**Comment Correction Required / Response Report**

**Application No. DEPN-23-0157**

Document Name	Document ID
2023-0718 - Wilson Tank DP Major Modification.pdf	15293478
CSU Wilson Water Tank - Staff Review.pdf	15328320

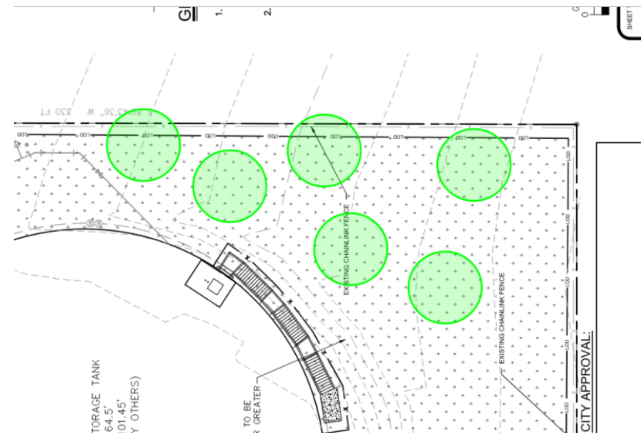
2)Furthermore, I think you need to add trees along the south boundary to reduce the skylighting of the tank from the dude ranch below. See image below. The grading on grading plan and landscape plan do not appear to match. If landscape plan is the final grading than the trees work as shown, but is more constrained if grading plan is showing the final grading around the tank. (photo below)

The proposed grading is now showing on the landscape plan. Additional trees have not been added within the suggested area as there are buried utility pipes and Utilities requires full access throughout the site and there is not enough room in that area to maintain truck access to the buried pipe and top of berm in addition to the trees.

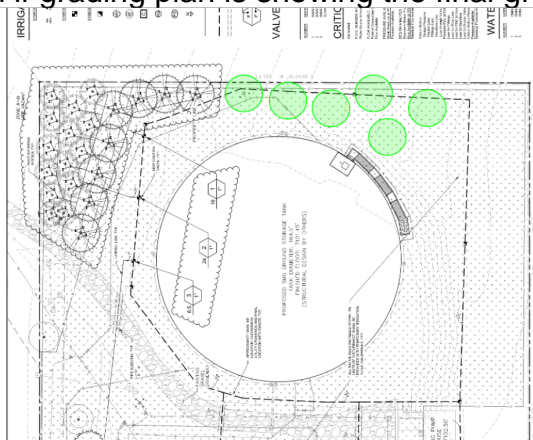
Here is another for trees along south p/l. You will need to make sure that LP and GP are showing same finished grading. This idea may have trees in the 2:1 slope around backside of tank as is shown on the GP. Last, with the size of Trees being planted please make sure that there is enough space for the rig to access the Site. (photo to right)
